SERVICE BULLETIN

GA107-7

1.1 Subject: Cyclic Stick Interference with P132 Console

1.2 Effectivity: Eurocopter AS350 Series helicopters with Eagle Audio P132 Console installed

FIGURE 1

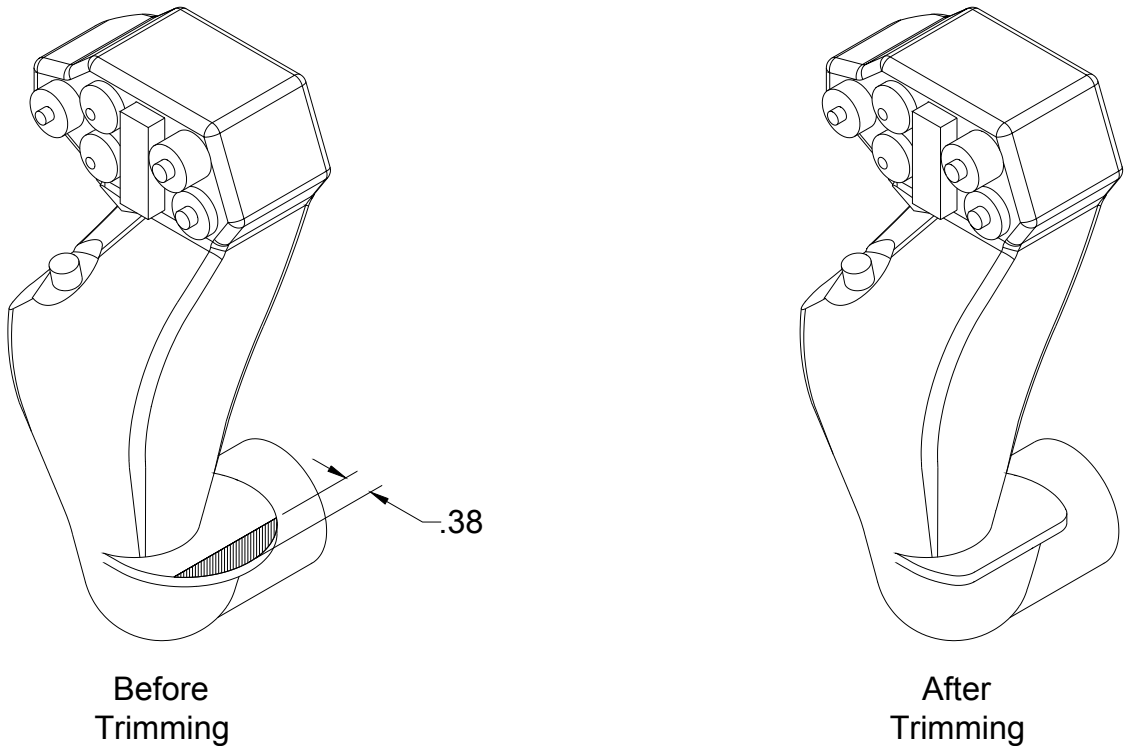
- 2.2 **Modification of Pistol Grip.** If the base of the grip has a flange that sticks out to help support the hand, remove 3/8" of this flange as shown in Figure 1 below. Sand the cut areas smooth. This step will be easier to perform if it is done after the grip is removed from the original stick during the stick replacement step. Both the Pilot and Copilot grips are to be modified.

FIGURE 2

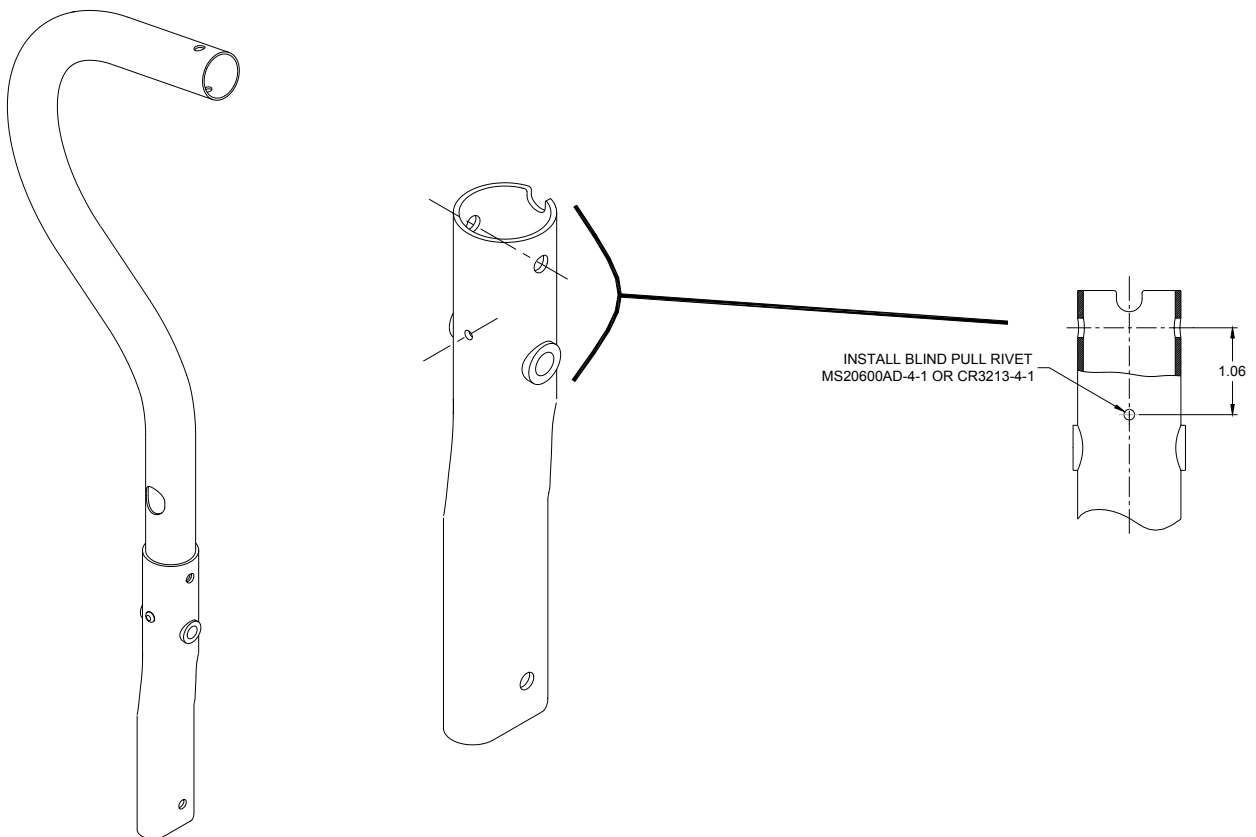
- 2.3 **Copilot cyclic stand (receptacle) modification.** This modification prevents the factory original copilot cyclic stick from being installed inadvertently into the aircraft. Only a Eagle Audio LH cyclic stick G12324-26 will be able to be installed once this modification is completed.

Remove the copilot cyclic stick stand (ref. p/n 350A27159403) from the aircraft. Install blind rivet as shown in Figure 2. Reinstall cyclic stand into aircraft and install Eagle Audio LH cyclic stick G12324-26 into stand as detailed in section 2.1.
